TS-SSC-91- 86

Subject: Coil Size Deviation of Long Dipole DCA^{3/0}~~320~~

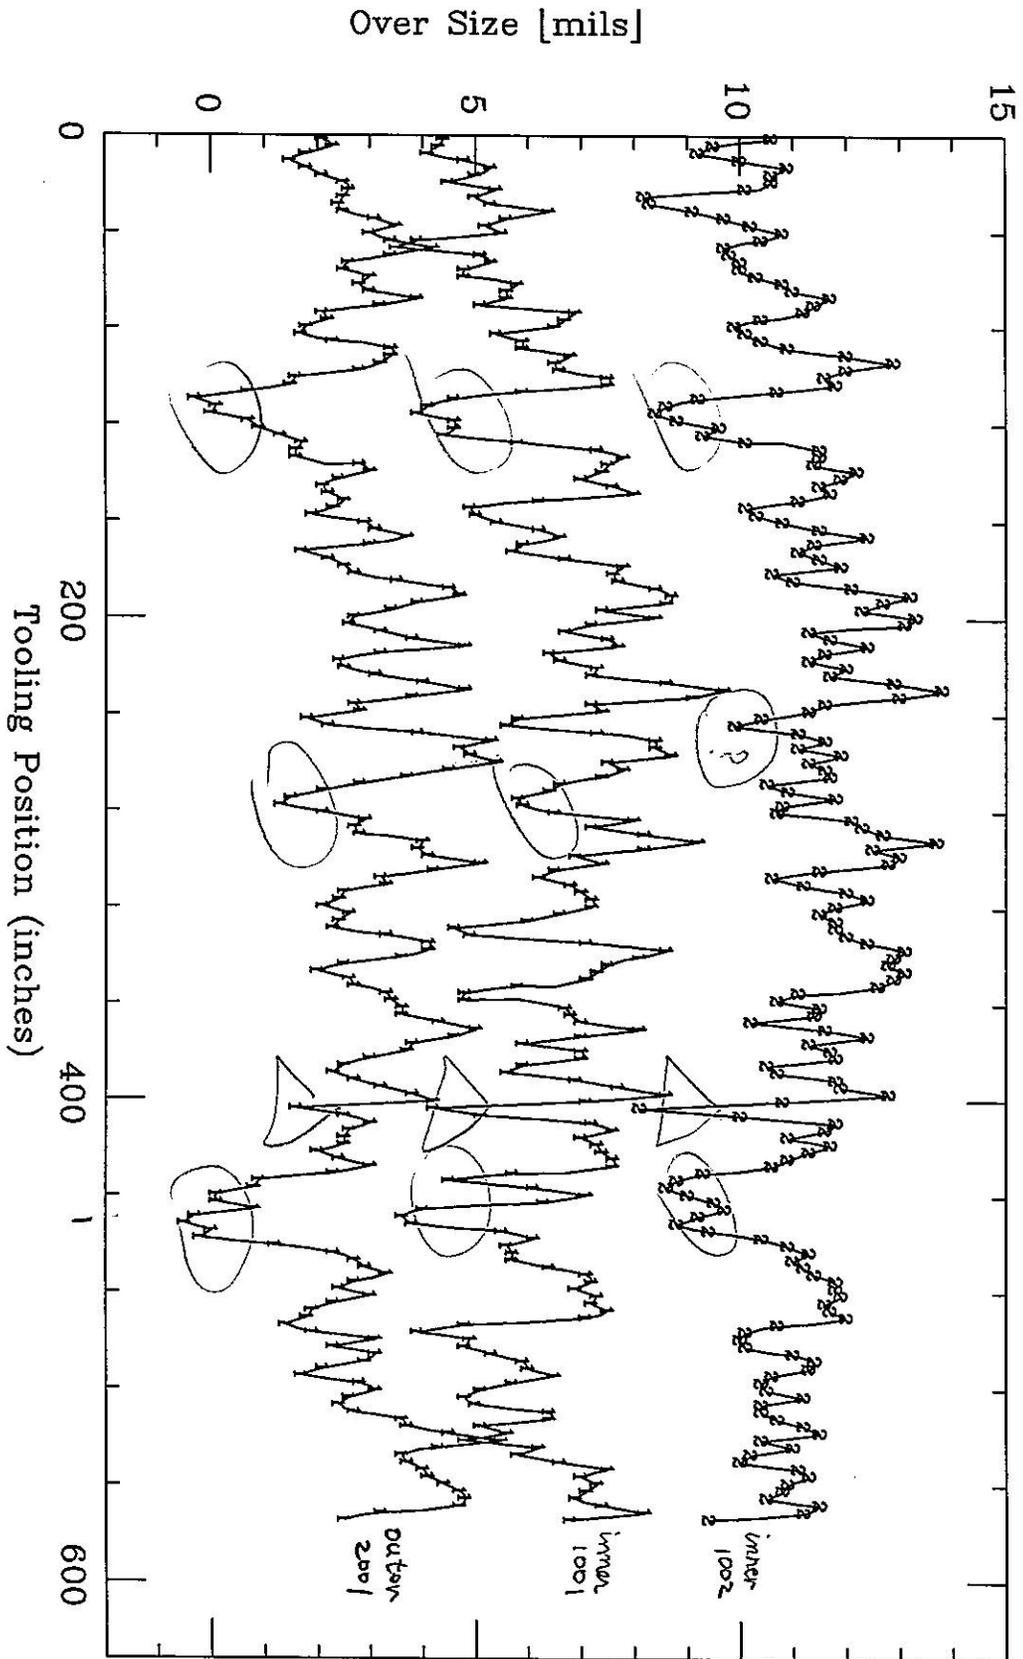
The first series of 50 mm long dipole coils were wound and the size data became available¹. Attached are the data of inner coil 1001,1002 and outercoil 2001. Though the averaged size is about what we expected, these coils have large deviation in coil sizes. It should be noted that all these coils have the same deviation pattern. There are large bumps at 120", 280" and 445" from lead end ². and this is common for both inner and outer coils. It is very suspicious this is coming from the press instead of the tooling. At the position 400", there is an asymmetric structure in the I/III side of the both inner and outer coils. The curing press should be inspected carefully at these positions.
